## C-1981-035 August Partial Inspection Report and Cover Letter

**Re: King Coal Mine Permit No. C-1981-035**  
**August 2023 Post Inspection Outstanding Maintenance Items**

Upon completion of the Division's August 16, 2023 inspection Six (6) required outstanding maintenance items were identified. These past due maintenance items are located in the King I Refuse Disposal Area. Please see the items listed below. **Corrective actions 1, 2, 3 and 5 must be completed by Tuesday September 5, 2023. Photographs and documentation must be submitted to the Division in order for the outstanding maintenance items to be considered resolved. If the outstanding maintenance items are not completed by September 5, 2023, The Division will pursue enforcement action. Maintenance Items 2, 3 and 4 are located on an excerpt of the King I Map 007 included at the end of this document as Attachment 1.**

Attachment 1:

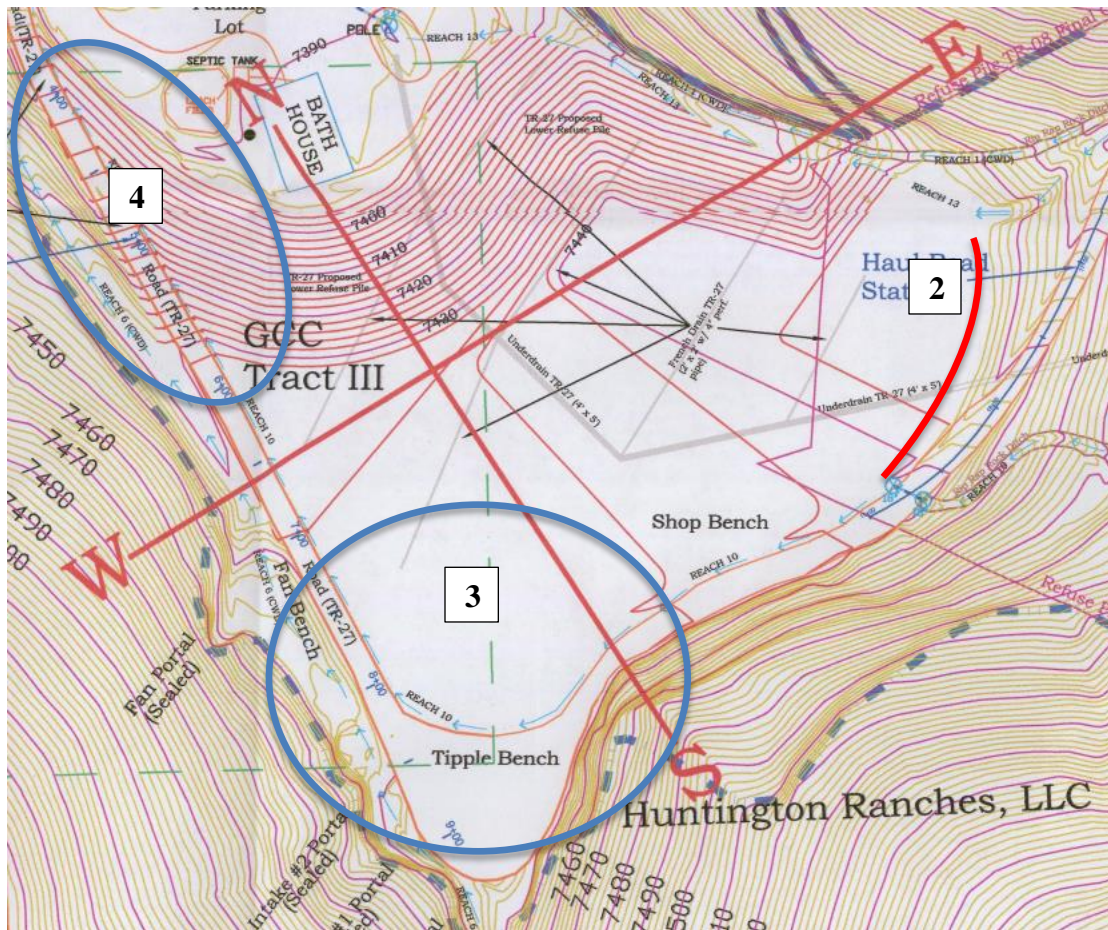
2. It was noted that the northeastern portion of the lower refuse pile has encroached on Reach 13 of the surface drainage features. The space between the lower refuse pile and the eastern Clearwater ditch has buried the location where the ditch should exist. This surface water drainage feature is no longer functional as designed and shown on Map 007. It would destabilize the lower refuse pile to remove refuse material from this area to restore Reach 13. Please re-route reach 13 where it intersects the top of the lower refuse pile. The Division recommends creating a segment of a ditch that connects Reach 13 along the southern portion of the refuse pile and connecting it to Reach 10. This new portion of Reach 13 should be made to the same size and dimensions as approved on King I Map 007A. **Please submit photos to the Division when this portion of the surface drainage system is completed.**

3. The Division's August 2023 Inspection identified that Reach 10 of the surface drainage features does not reflect the design or location as presented on the approved King I Map 007. Reach 10 no longer follows the haul road along the south-southwest section of the lower refuse pile. **Please restore this section of Reach 10 to reflect the location and design presented on Map 007. Submit photos to the Division when this task has been completed.**

4. The northwestern section of reach 10 has had erosional problems in 2023. The operator has redesigned this section of Reach 10 to help slow and control the flow of water off of the lower refuse pile. The Division believes that this design will be more effective at routing surface runoff from the lower pile. However, the current location and design of this section of Reach 10 is not reflected on Map 007 and Map 007A. Additionally there are no current SEDCAD designs supporting this drainage design in the current Permit Application Package. **A Technical Revision is required to remedy this deficiency. Please create a Technical Revision Application to update the Permit Application Package with a new Map 007, Map 007A, SEDCAD designs and all accompanying permit text to reflect the new ditch design and location. This Technical Revision can be included with the required remedy for Item No. 6.**
